Docket Item # 3
BAR CASE #2009-0028

BAR Meeting
March 18, 2009

ISSUE: Awnings
APPLICANT: Carr 625 First Street, LLC
LOCATION: 625 First Street
ZONE: CD/Commercial

BAR CASE #2009-0029

Figure 6: Illustrative of Front Elevation showing proposed awnings

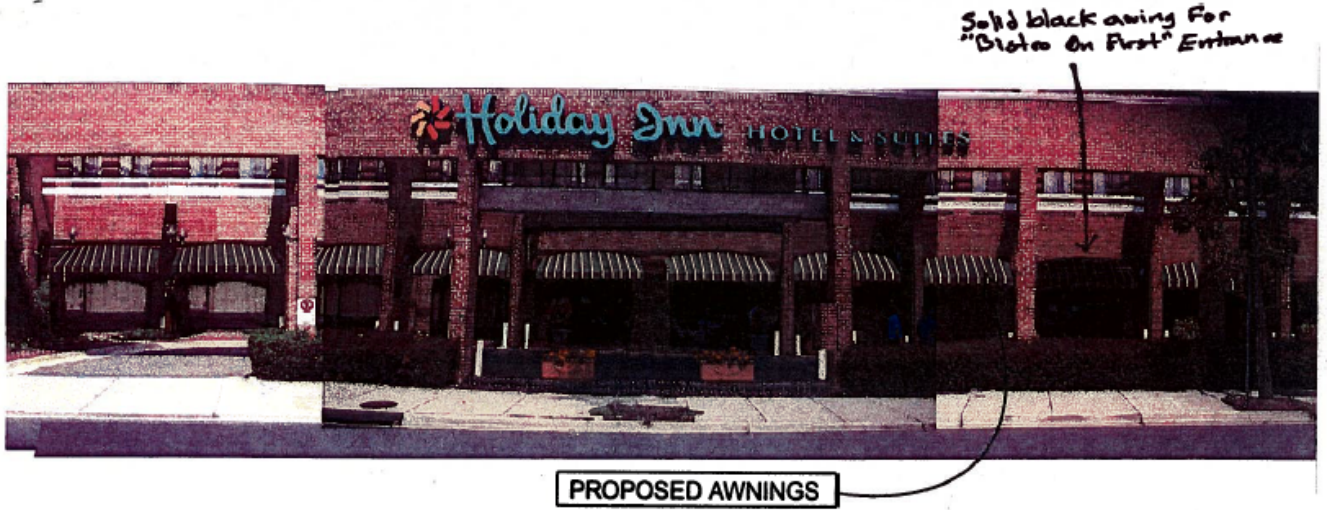
STAFF RECOMMENDATION: Staff recommends approval of the application with the condition that the awnings be mounted through the mortar joints and not through the brick masonry.

The proposed awnings will be located above existing fixed sash windows along the south elevation. The awnings will be generally rectangular in shape but will have an arch top where the awning meets the brick façade, to correspond to the arched top of the window opening. The applicant is proposing a new sign for the “Bistro on First” to be placed above the restaurant window. Except for the black Sunbrella awning for “Bistro on First”, the awnings will be detailed in loden and ivory striped Sunbrella fabric.

Each awning will be a shed roof form and measure 12’ long by 3’ wide and not exceed a height of 2’.

Regarding the color of the awnings, the *Guidelines* note that “The color should be appropriate to the building. Single color awnings are usually appropriate for buildings with extensive façade ornamentation. Striped awnings are generally only appropriate on buildings with simple and unadorned facades.” Twelve (12) of the awnings proposed are to be fabricated of a loden and ivory striped Sunbrella fabric. These awnings are to be mounted above the fixed-sash windows along the hotel’s south elevation. This hotel is modern and simplistic in its form and as such the striped awnings will complement its’ “simple, unadorned” façade.

The proposed single, black awning to be mounted above the restaurant window will be ornamented with 5" white letters denoting the restaurant name “Bistro on First”. This separate awning design breaks up the awning’s repetition on this very linear façade.

IV. STAFF RECOMMENDATION: Staff recommends approval of the application with the condition that the awnings be mounted through the mortar joints and not through the brick masonry.

C-2 Awnings must comply with all applicable requirements of USBC 3105.3 and 3202.3.1. Retractable and fixed awnings must have a minimum 7 foot clearance from a sidewalk to the lowest part of the framework or any fixed portion of any retractable awning is required. Retractable awnings must be securely fastened to the building and cannot extend closer than 24 inches in from the curb line (USBC 3202.3.1).

C-2 Fixed awnings must be designed and constructed to withstand wind or other lateral loads and live loads required by the USBC. Structural members must be protected to prevent deterioration (USBC 3105.3).

Figures 8: Specifications for Awnings

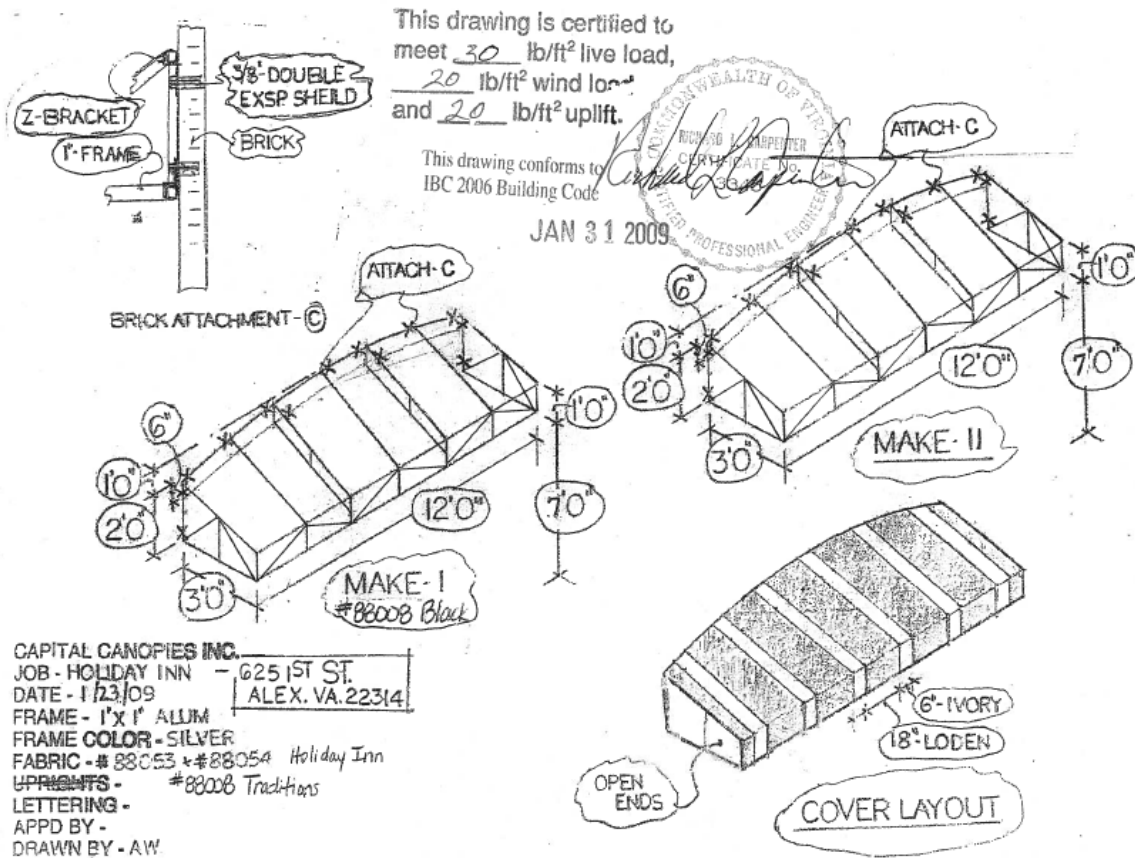
120' long for a total of 540 square feet (see photos Figures 3 and 4). The new awnings will be constructed in a metal shed roof form wrapped in fabric—specifications recommended in the *Guidelines* and occupy 468 total square footage of space.
